**Rotax Motor Type 914 F Serie, Kontrolle / Austausch des Wastegate-Seilzuges**

**Rotax engine type 914 F series, check / replacement of the wastegate servo cable**

Check / replacement of the turbocharger wastegate servo cable (part no. 897.940).

All versions of engine **type 914 F series from S/N 4,420.002 up to and including S/N 4,420.127.**

Bild / Fig. 2

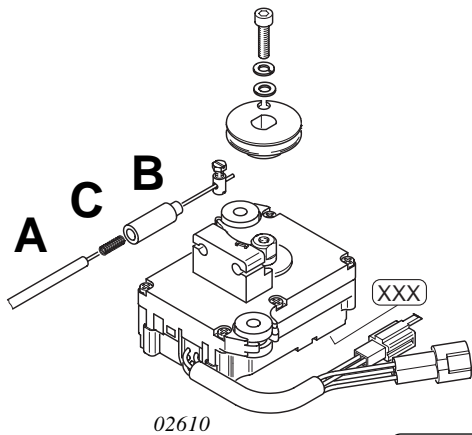
Ensure that the pressure spring in the spring socket is in the right position. See Fig. 2.

Bild / Fig. 1

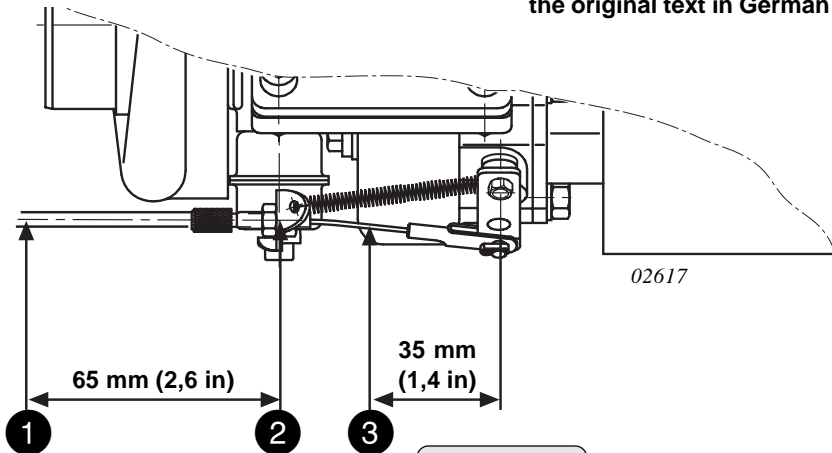
Following temperatures must be measured on the positions set out in figure 1 and must **not** be exceeded during take off and after engine stop (heat accumulation).

pos.	description	temperature
①	cable conduit	max. 120 °C (250 °F)
②	cable support	max. 120 °C (250 °F)
③	wire rope	max. 140 °C (280 °F)
